Process Change Notification (PCN)

Notification number:	011524-1
Notification date:	15 Jan 2024
Proposed implementation date:	15 Apr 2024 (90 days notification before change, according to JEDEC standard)
Product type affected:	Please refer to table 4&5 in Appendix 1.
Change Category	Product design
Change Classification	Major
Change description:	<ol style="list-style-type: none"> 1. Plating process change: Production transfer to high-speed plating line(Rack Plating), to improve production efficiency. (Please refer to table 1 in Appendix 1) 2. Molding equipment change: Changing from semi-automatic molding equipment to automatic molding equipment improves product production efficiency and quality. (Please refer to table 2 in Appendix 1)
Reason for change:	<ol style="list-style-type: none"> 1. Improve equipment automation capabilities, Improve product production efficiency and quality. 2. Optimize pin forming shape, reduce mechanical stress during forming, and improve product quality.

PCN Title: Automation Improvement for SMD Automotive Series .

Appendix 1: Table 1

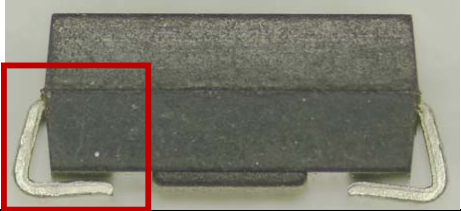
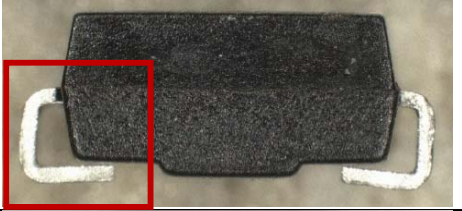
Change description	Before the change(Barrel Plating)	After the change(Rack Plating)
Plating process change(Process Flow Chart)	Trimming→Reflow→Plating	Pre-Trimming→Reflow→Plating→Trimming
